TRANSMITTAL

PROJECT : MMCEASTTOWER
CUST. NO. : 310

VIA : CUSTOMER WEB SITE
FOR : APPROVAL

Submittal No. 051200-0005-0

JOB NO.	DRG NO.
7272	E100A

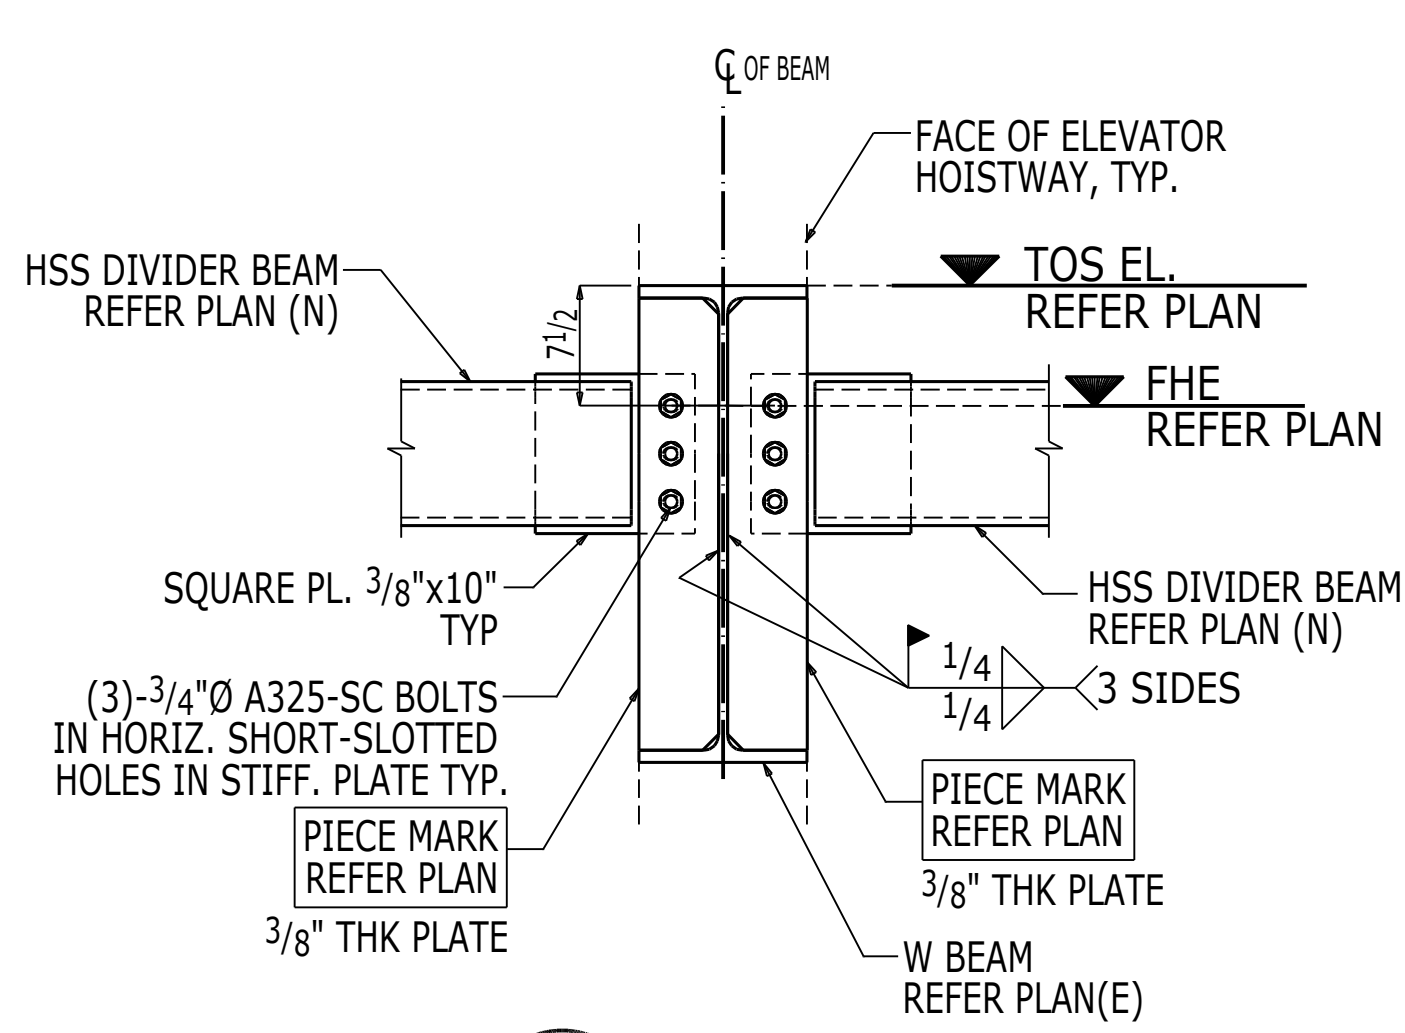
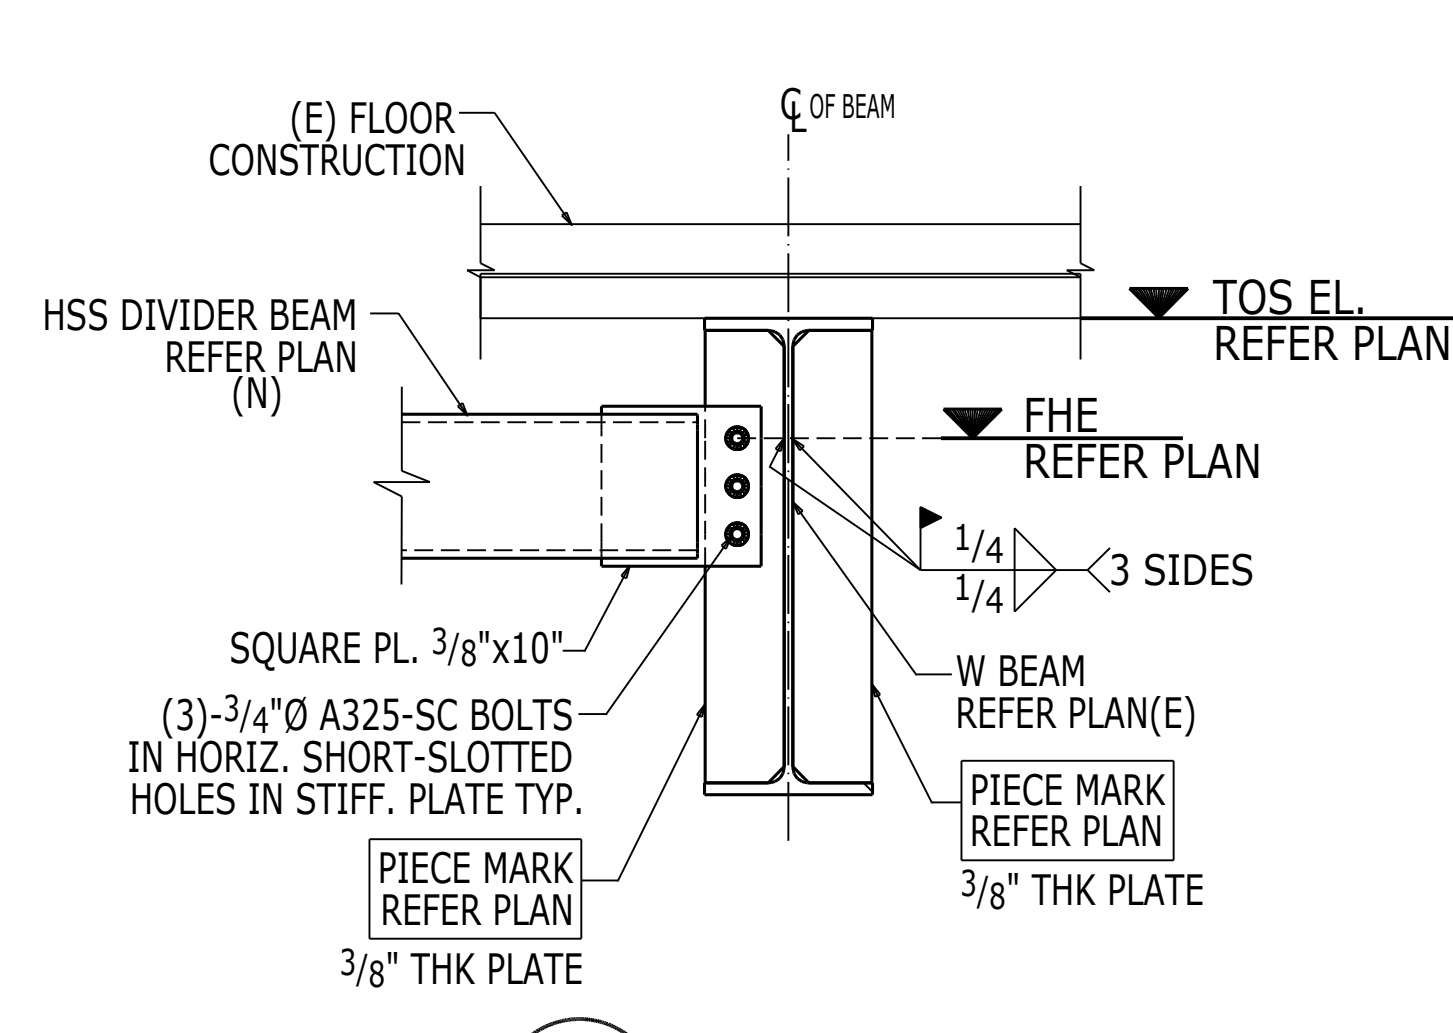
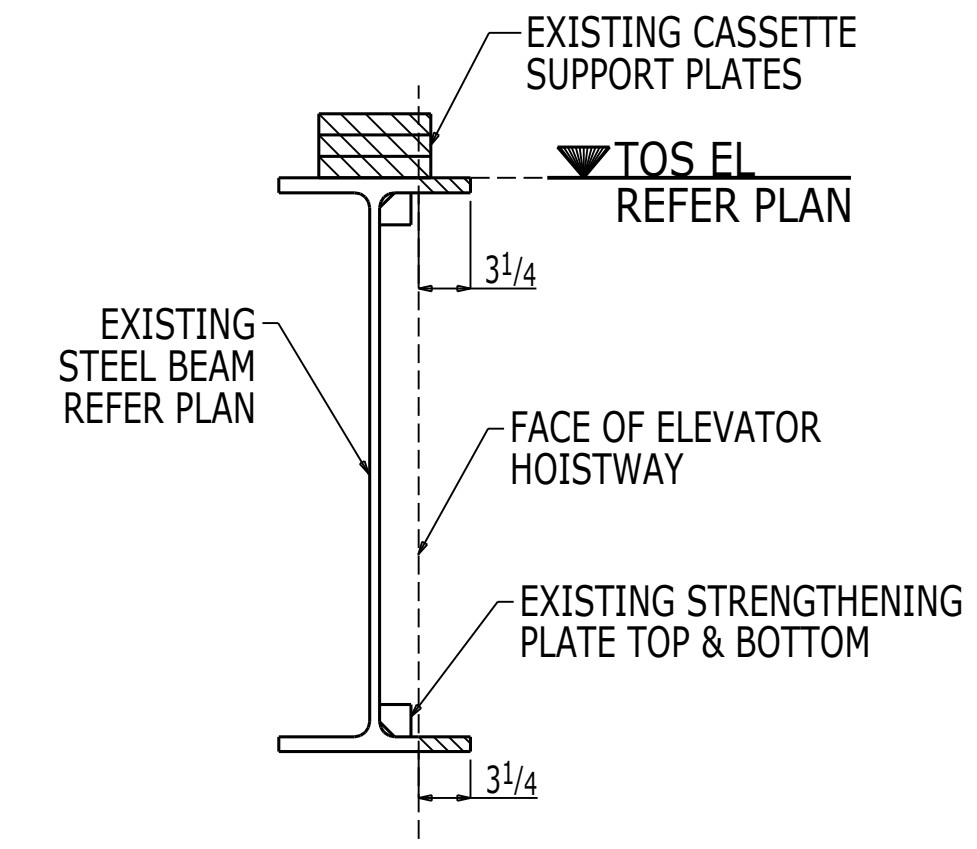
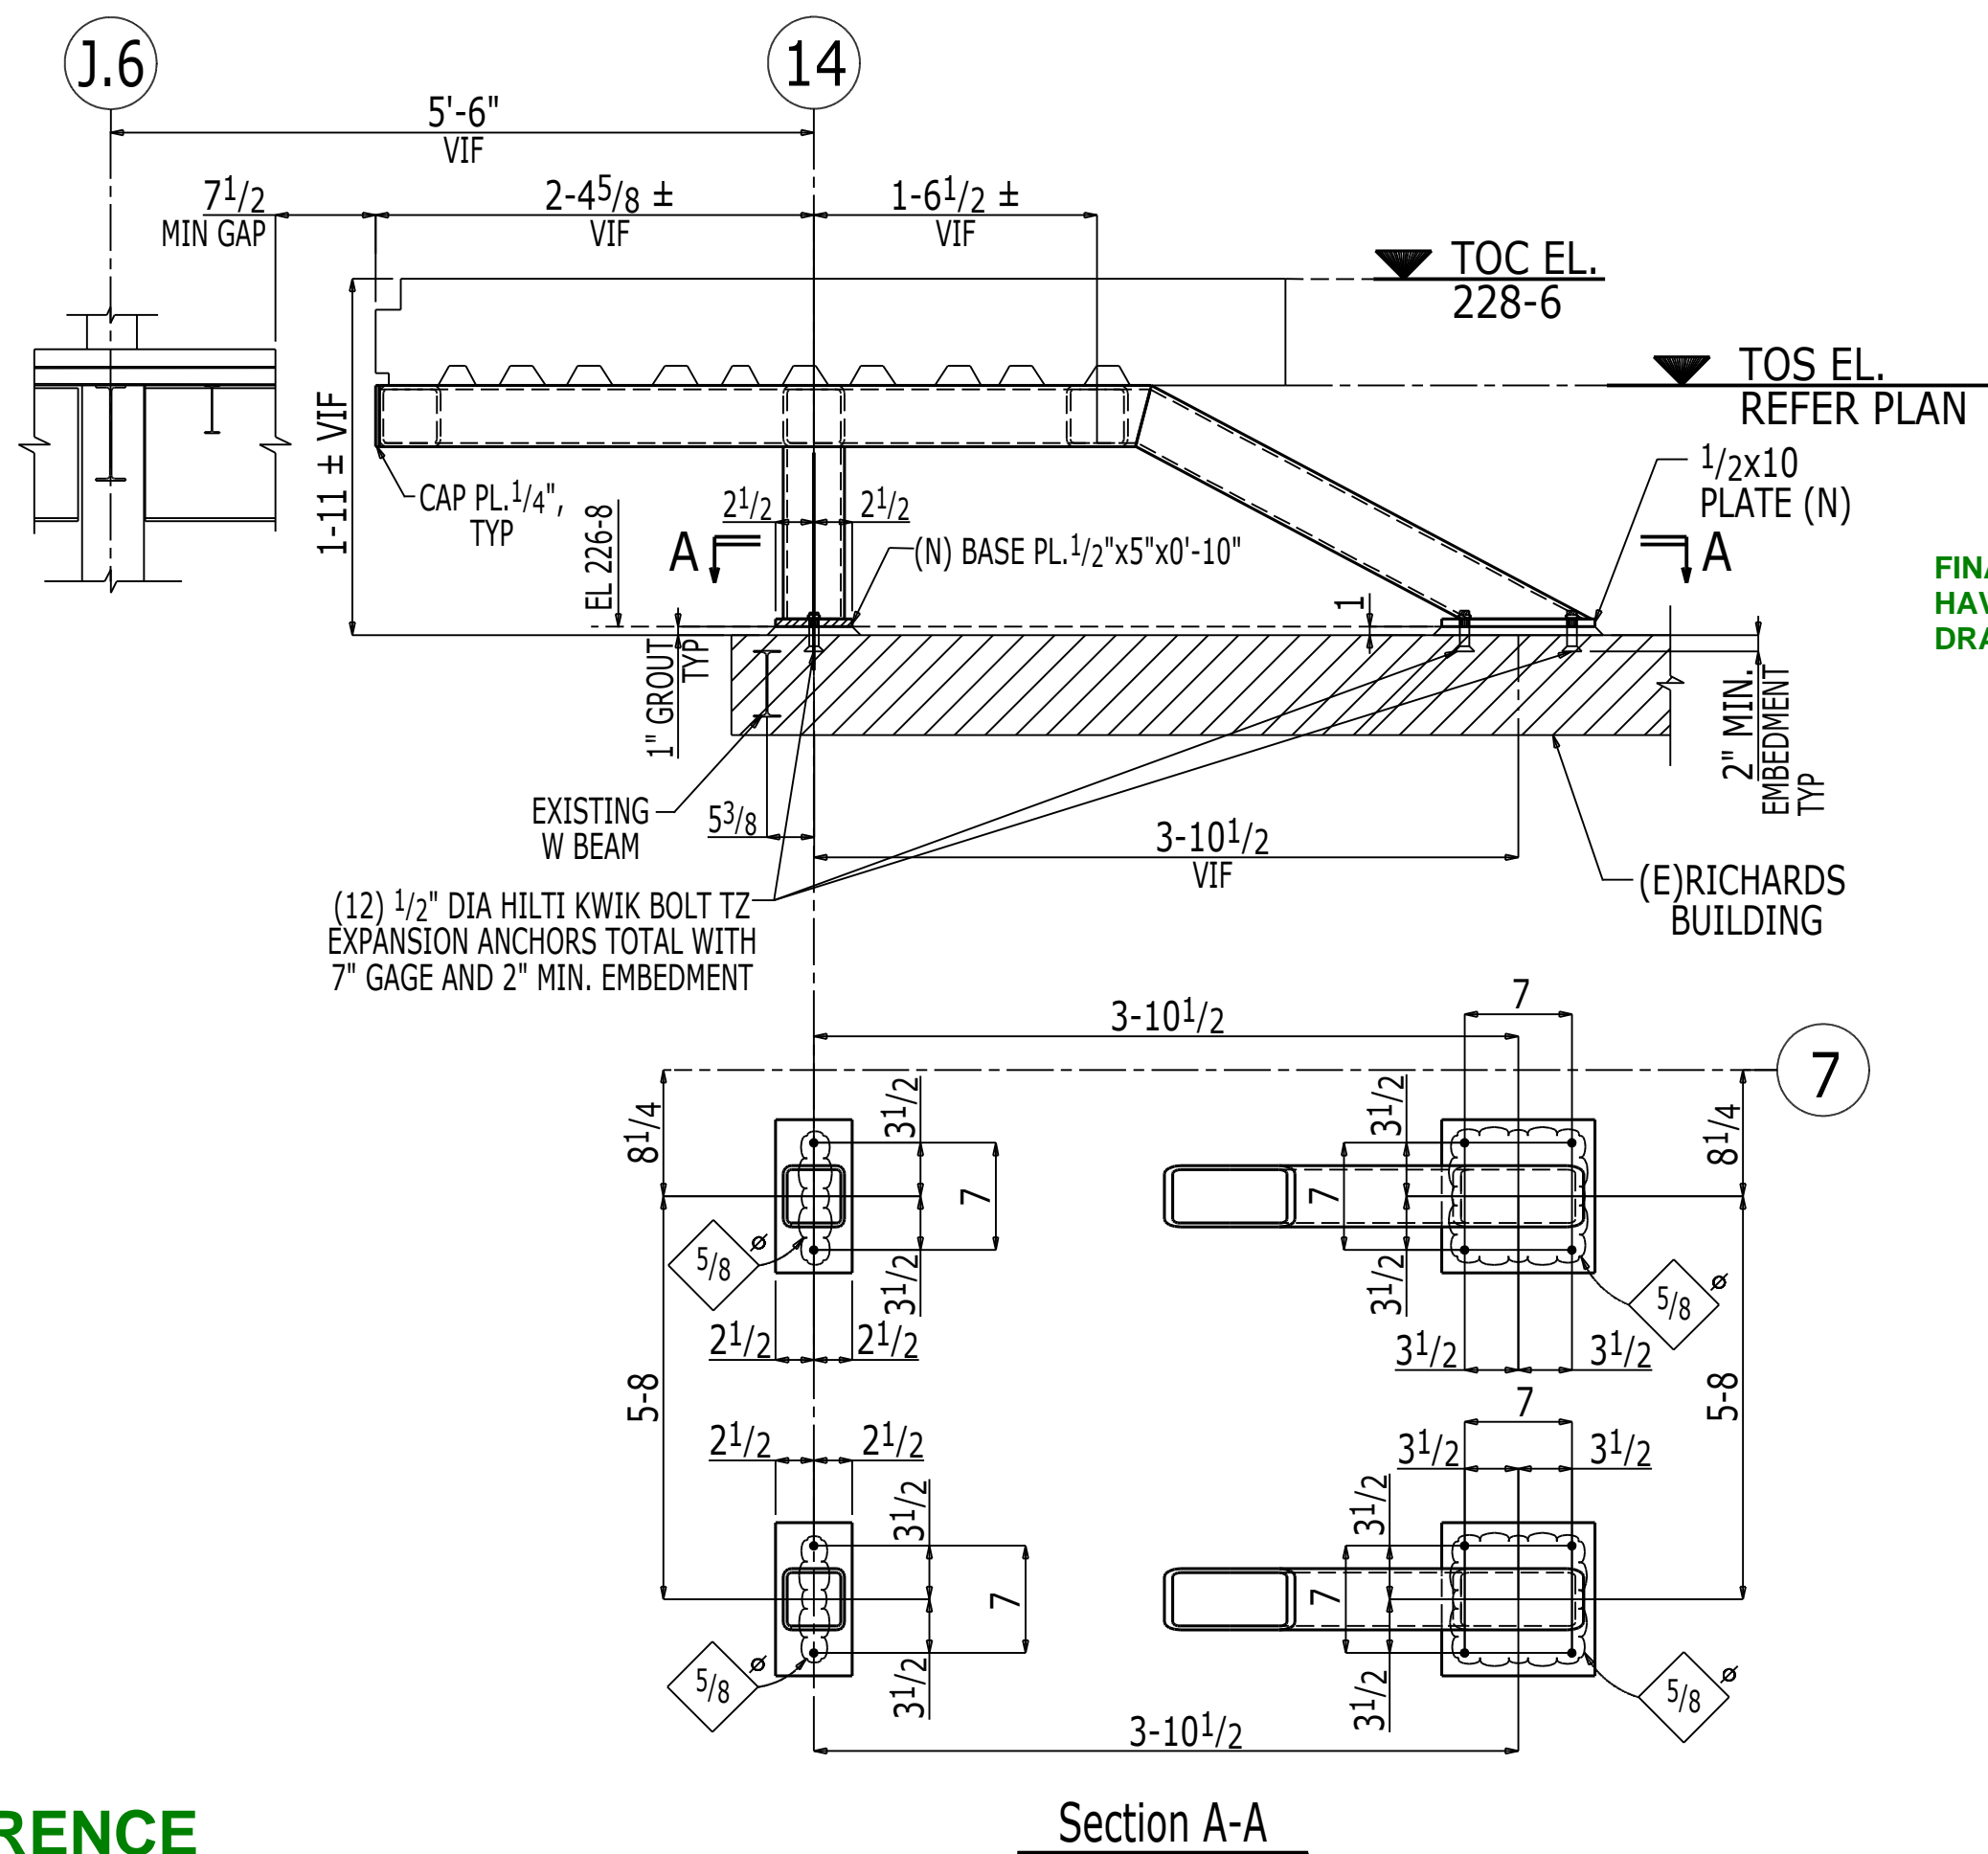
FINAL CONDITIONS AT RICHARDS BUILDING WILL HAVE TO BE VERIFIED AND INCLUDED ON THIS DRAWING PRIOR TO A FORMAL APPROVAL - RJM

JOB NO.	DRG. NO.
7272	E100C

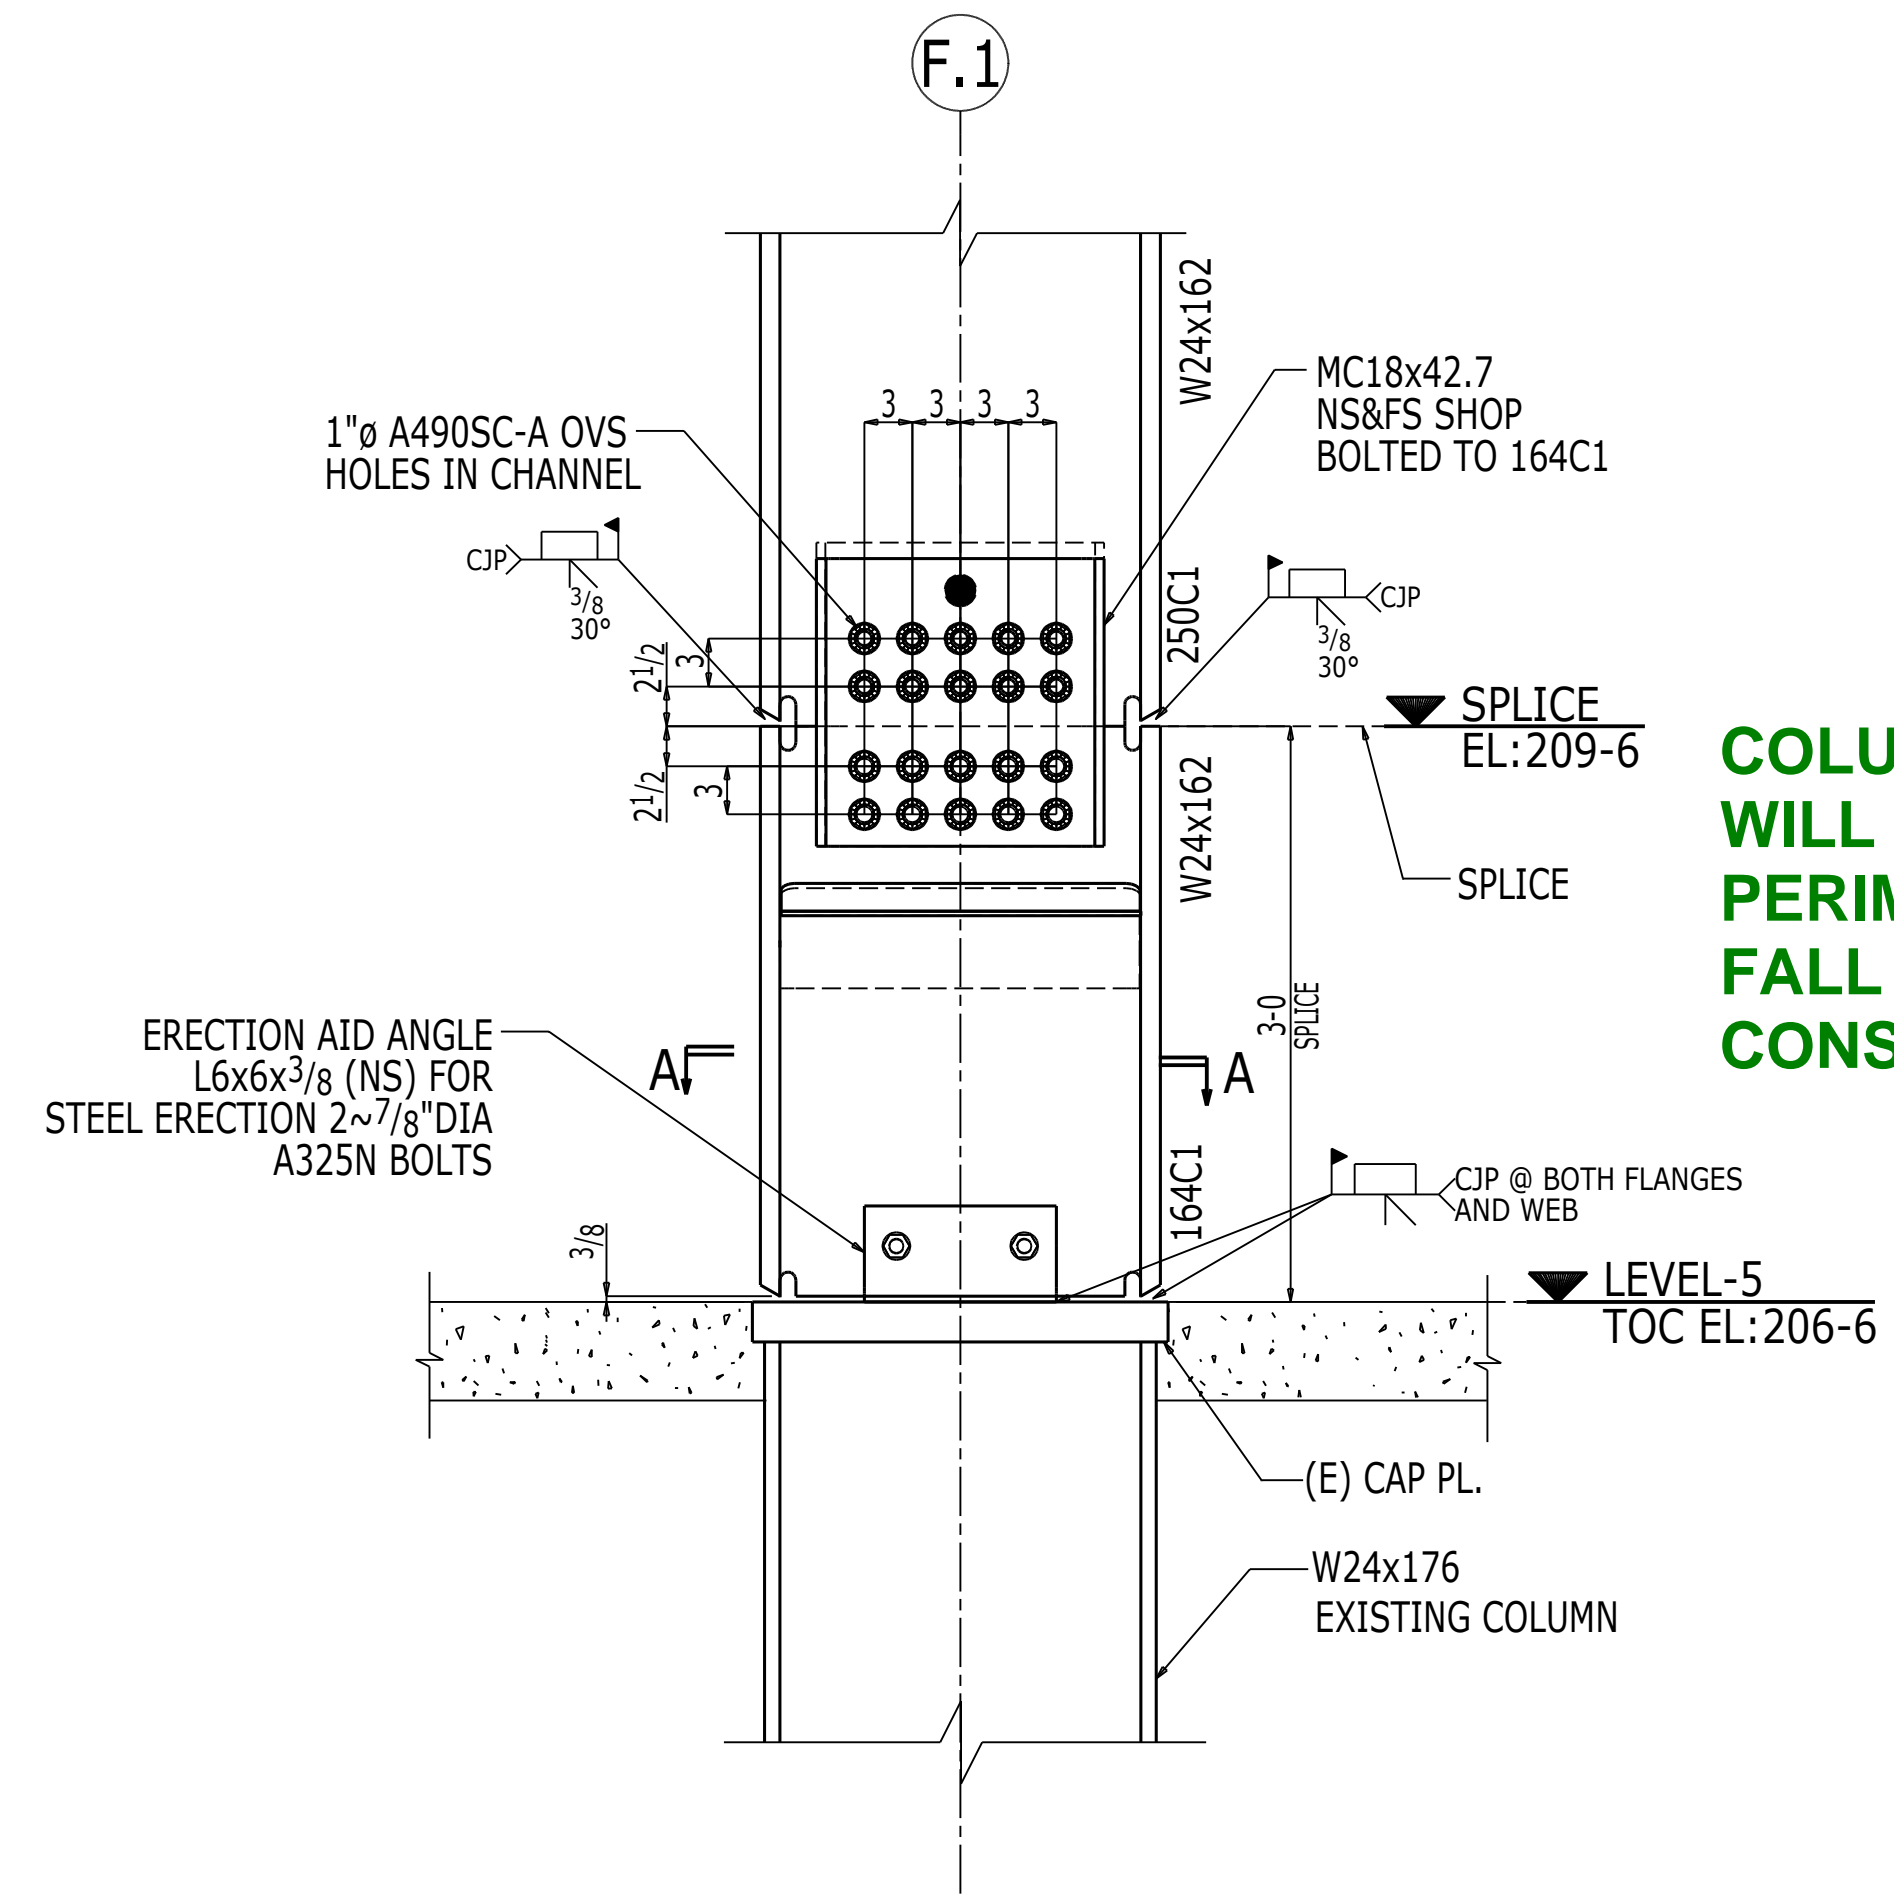
COLUMN STUBS AT INTERIOR COLUMNS WILL BE 3' HIGH, COLUMN STUBS AT PERIMETER WILL BE 6' HIGH TO SUPPORT FALL PROTECTION CABLES DURING THE CONSTRUCTION - RJM
